**REGULAR MEETING OF THE
CITY OF CONCORD
DESIGN REVIEW BOARD**

- 1. [2090 Diamond Boulevard Commercial Development](#) (PL1500042 – DR) - Design Review to demolish an existing 9,500 sq. ft. vacant (previous Marie Callender's) building to construct a new approximately 6,470 sq. ft. restaurant with outdoor patio and adjacent commercial leases space of approximately 6,700 sq. ft. in size at the southeast corner of Galaxy Way and Diamond Blvd. Associated improvements including modifications to parking, landscaping, and lighting on a 1.45-acre site at 2090 Diamond Boulevard. The General Plan designation is West Concord Mixed Use; Zoning classification is WMX (West Concord Mixed Use); APN 126-490-001. Project Planner: Joan Ryan @ (925) 671-3370.**

1. **Chalomar Crossings Subdivision (PL150027 – DR)** – Study Session for Rezoning from RS-7 to RL, Major Subdivision tentative map to create 20 lots, Planned Development Use Permit, Design Review, and a Tree Removal Permit on a 2.48-acre site located at 988 Oak Grove Road. The General Plan designation is Low Density Residential; Zoning classification is RS-7 (Single-Family Residential 7,000 square foot minimum lot size); APN 129-210-015. **P

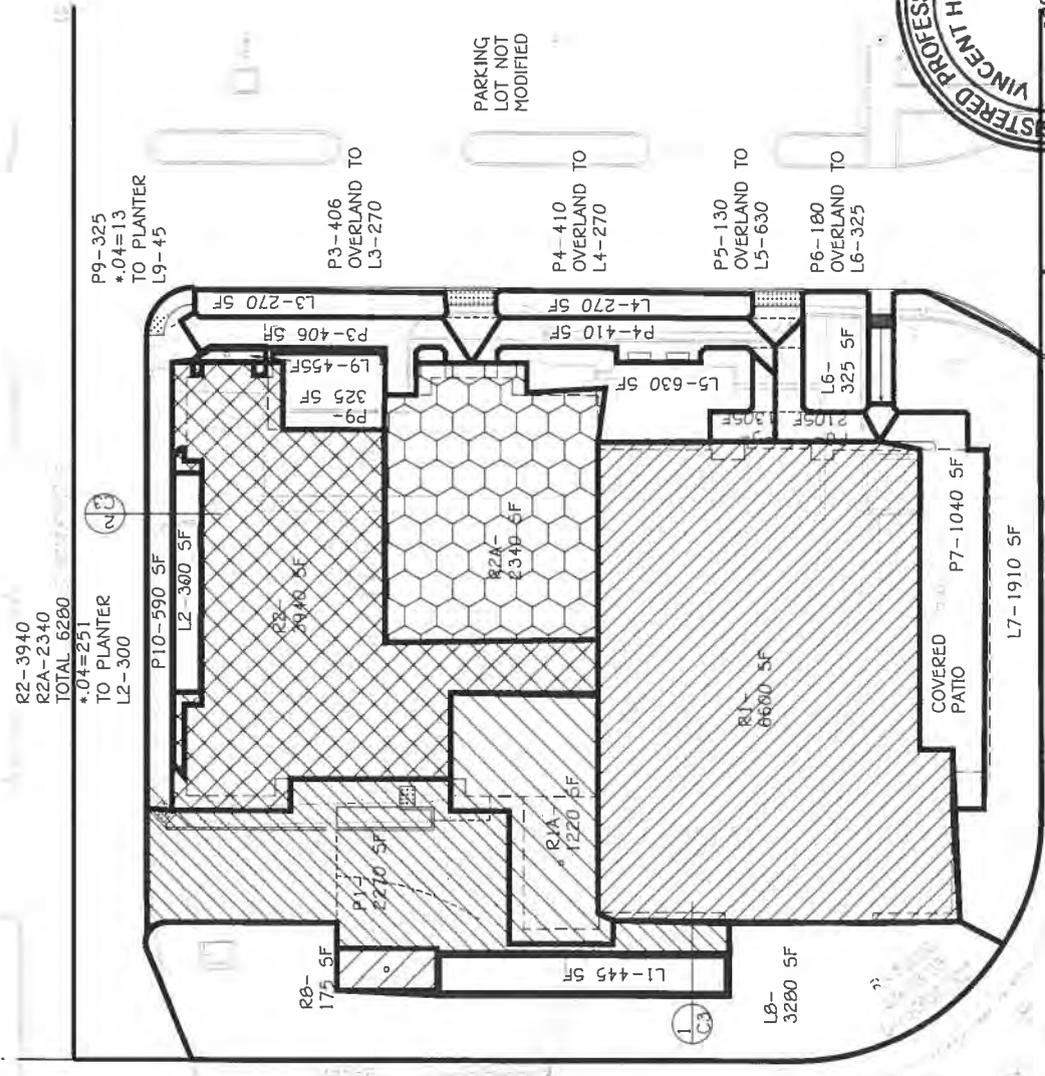
The site is planned to drain similar to the existing development where storm water is captured on site and routed through an existing storm drain to the existing storm drain inlet on Diamond Blvd. However, water infiltration planters are proposed to meet C₃ requirements and accommodate storm water flows in three locations at the north, east and south (front) side of the building. Flow through treatment planter details are on Sheet C-3.
